**CITY OF CENTRAL POINT
PLANNING COMMISSION AGENDA
January 19, 2021 - 6:00 p.m.**

COVINGTON COURT SUBDIVISION

**PLANNING DEPARTMENT SUPPLEMENTAL FINDINGS OF FACT
AND CONCLUSIONS OF LAW
File No.: SUB-20004**

Consideration of a Major Modification to the White Hawk Master Plan (File No. 14004) concerning the phasing plan and alley layout, architectural style, and housing type in Phase 1. The 18.91 acre project site is within the Low Mix Residential (LMR) and Medium Mix Residential (MMR) zones in the Eastside Transit Oriented Development District (ETOD) and is identified on the Jackson County Assessor's Map as 37S 2W 02, Tax Lots 2700 and 2701. **Applicant:** White Hawk Properties, LLC; **Agent:** Urban Development Service, LLC (Mark Knox). **File No.** MOD-20005.

Figure 1. Tentative Plan

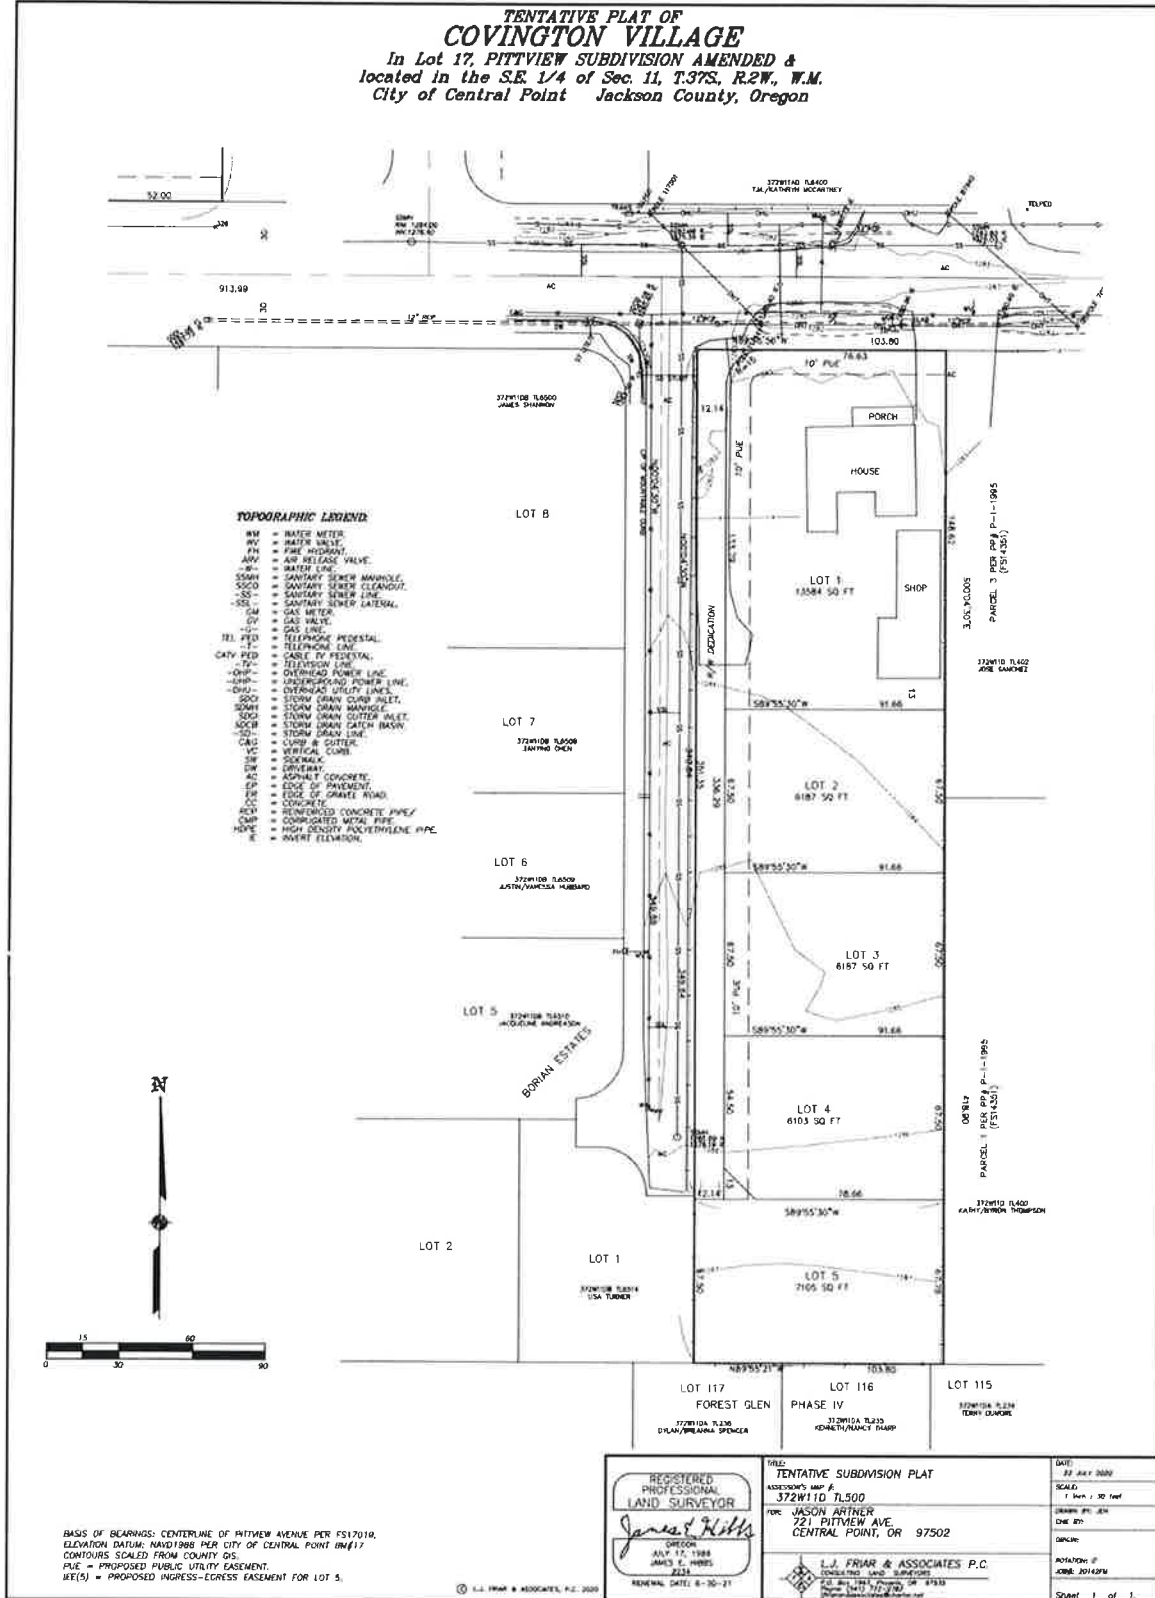
During the review of the application, it was noted that the development will need to address stormwater management and identify how surface water runoff will be conveyed and treated. The west side of Covington Court features a rolled curb that is ineffective in directing large amounts of runoff. Homes on the proposed lots must be constructed high enough to provide positive drainage away from the house and underdrain.

Comment: The stormwater management plan must provide adequate drainage to the street and prevent stormwater and drainage issues to adjacent properties. Per the Public Works Staff Report (Attachment “D”), the Applicant shall submit and receive approval for a stormwater management plan to the Public Works Department, demonstrating compliance with the Rogue Valley Stormwater Quality Design Manual for water quality and quantity treatment.

1. Stormwater Management Plan – The Applicant shall submit and receive approval for a stormwater management plan to the Public Works Department, demonstrating compliance with the Rogue Valley Stormwater Quality Design Manual for water quality and quantity treatment. Construction on site must be sequenced so that the permanent stormwater quality features are installed and operational when stormwater runoff enters.

Figure 2, Proposed Phasing Plan Revision (See also, Attachment "A-1")

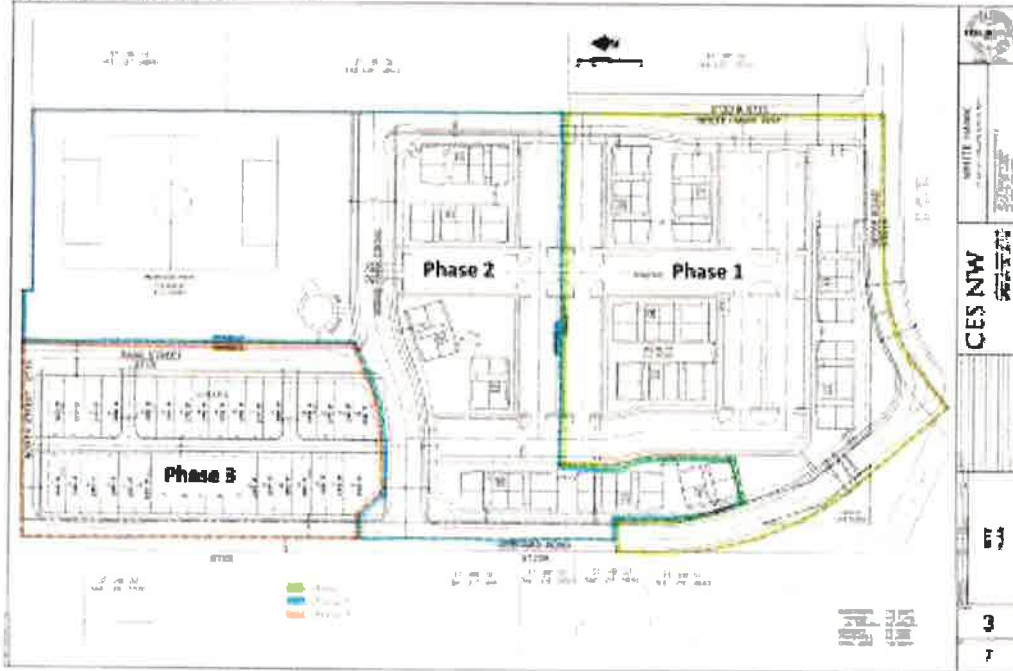
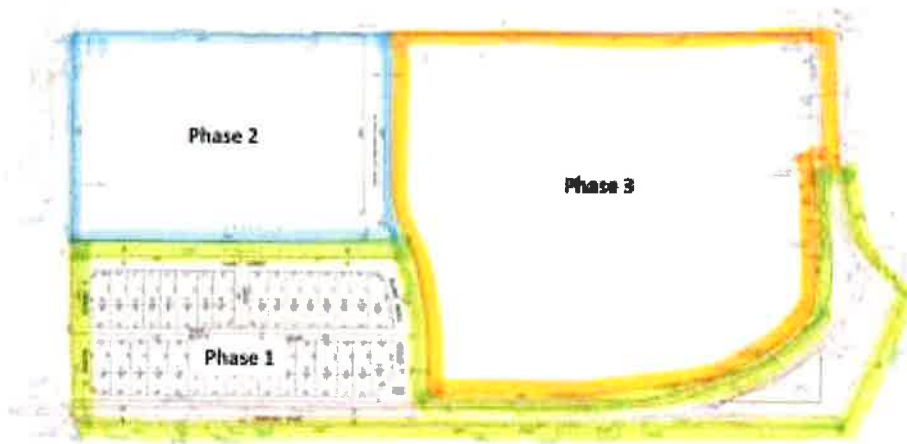
The original phasing plan (Figure 1) addresses timing and implementation of traffic park construction and mitigation of traffic and environmental impacts of the White Hawk development. As shown in Figures 1 and 2, the proposed change to the phasing plan changes Phase 3 to Phase 1. To comply with the original

master plan requirements, the Applicant proposes to realign the intersection of Gebhard and Beebe Road to provide a safe turning radius. Proposed Phase 2 is the Park and Phase 3 includes the apartment development. Aside from timing, no changes are proposed to either Phase 2 or 3 at this time.

Figure 1 – Location of Wells in the White Hawk TOD

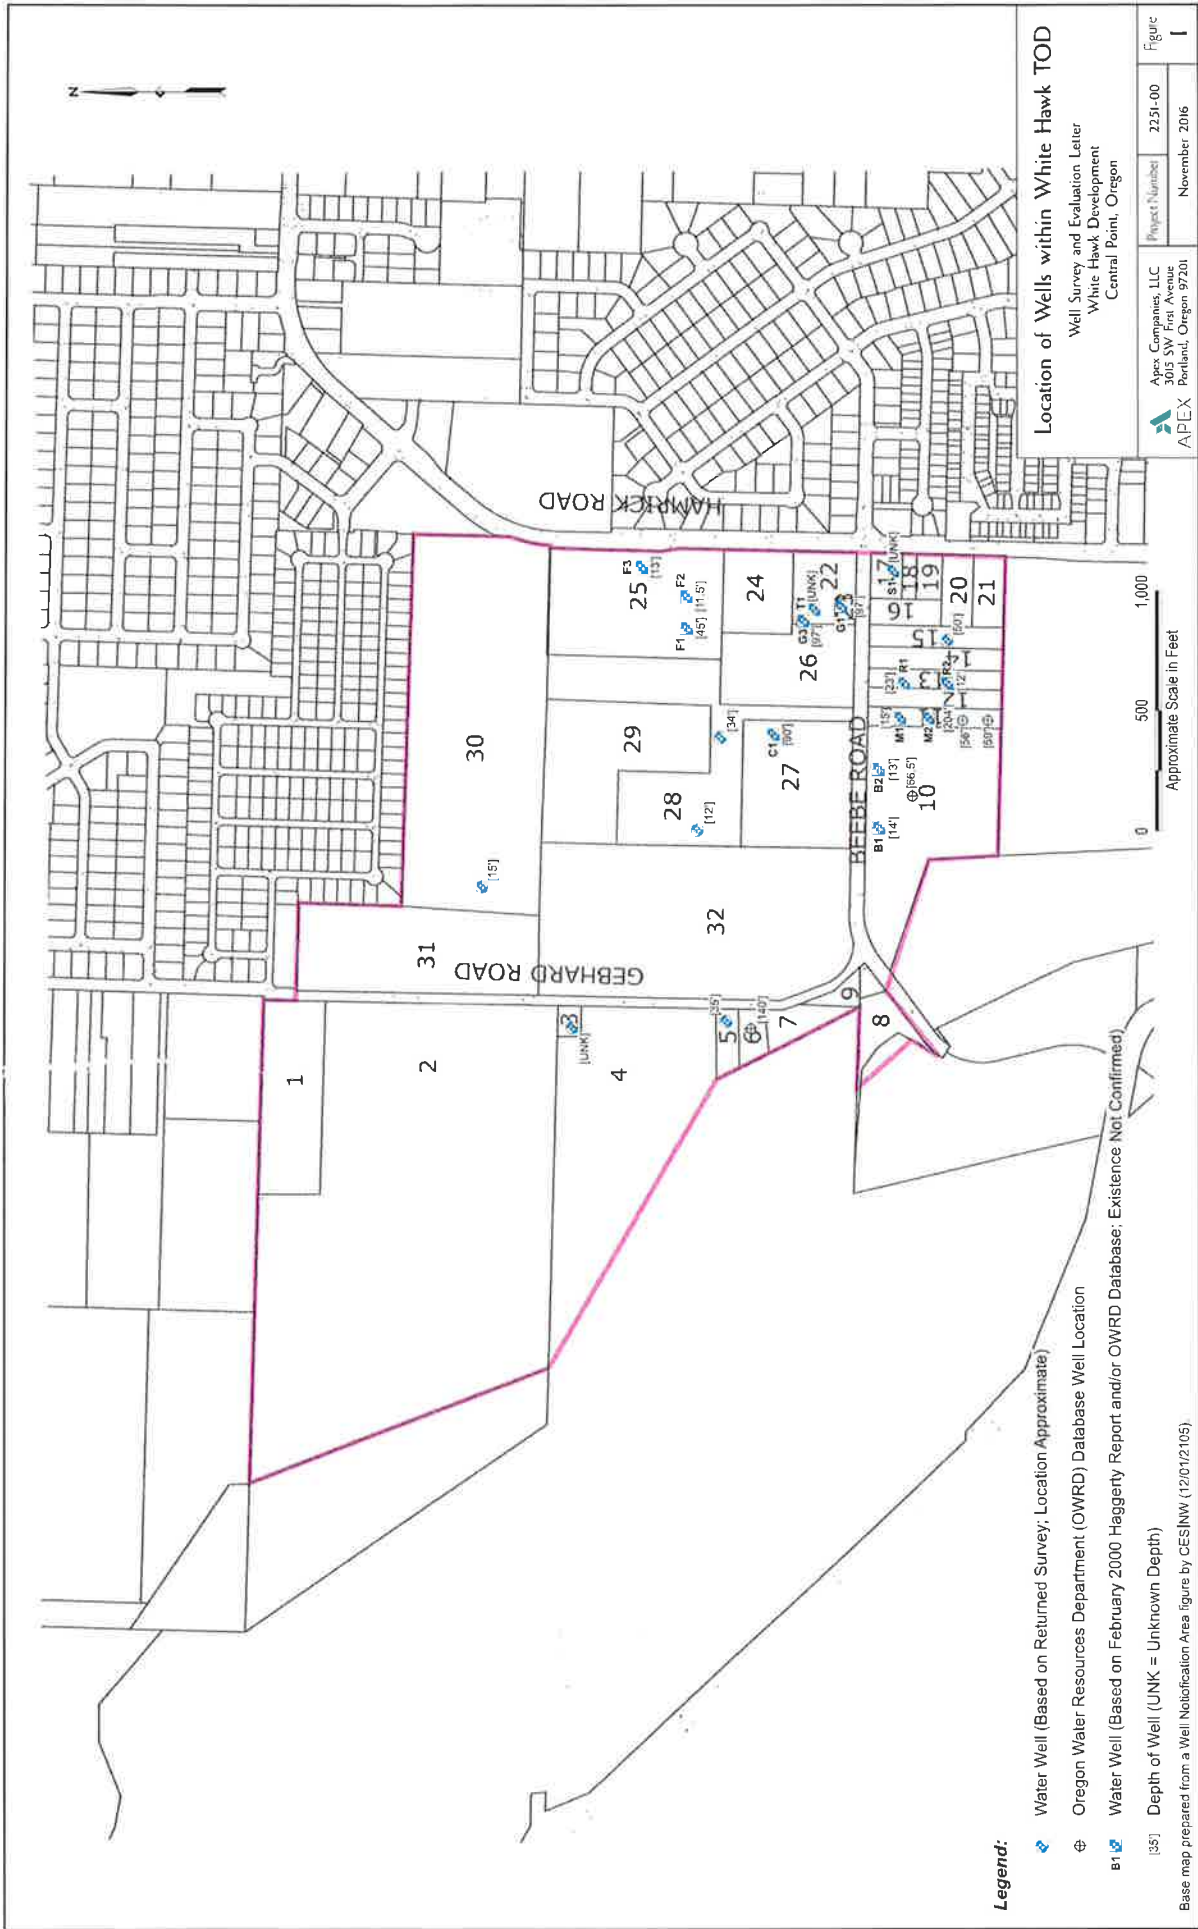
Figure 1 shows that most of the wells are more than 100 feet from the proposed stormdrain line to be installed beneath Gebhard Road. However, wells are reported at parcels 3, 5, and 6 (see Figure 1) and the location of the wells are not known so the wells could be closer to the proposed utility.

- Up to 21 wells may be located in the vicinity of the proposed project; it is unclear how many of these wells are still in use, however, at least three wells that are likely in use appear to be located within 100 feet of the proposed installation along Gebhard Road. The proposed utility installation is not expected to impact two of these wells because the wells are 35 and 140 feet deep and access water well below the depth of utility installation. The third well, located on parcel 3 (Figure 1) is of unknown depth. It is also unlikely that the utility installation will impact this well because the utility installations will penetrate only a few feet into the water table, if at all, at this location.

- A 12-foot depth well is reportedly located on parcel 28 that may be within 100 feet of proposed storm and sewer lines to be installed along the eastern development boundary (Figure 1). There is the potential that this well could be impacted by the utility installation, if the line extends into the water table at this location.

3. **Shallow Well Mitigation.** To avoid potential impacts of the development process on the water table and shallow wells, the prior property owner was required to survey and sample identified wells in the vicinity of the project site. This work was completed between December 2015 and April 2016 and a report was prepared including recommended mitigation actions for the design and construction of underground utilities. Per the Public Works Staff Report dated January 4, 2021, the Applicant is required to address the shallow well mitigation requirements prior to Civil Improvement Plan approval and the start of construction.

Comment: Staff recommends that the Planning commission approve Condition No. 2 that the Applicant satisfy all Public Works conditions of approval in the Staff Report dated January 4,
